SERVICE INSTRUCTION**Introduction of a new turbocharger assy. with new ECU software and exhaust requirements for ROTAX® Engine Type 915 i A (Series)**

ATA System: 78-20-00 Turbocharger

In the course of further development and standardization, a new turbocharger assy. has been introduced.

Fig. 1

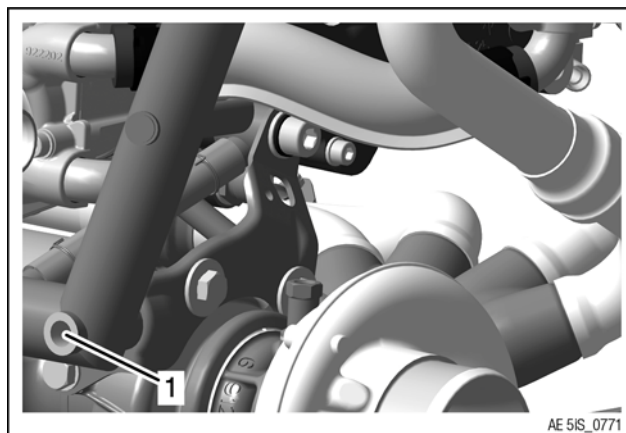
**NOTICE** Connection turbocharger bracket with engine suspension frame requires a Metric or UNF fixed connection.
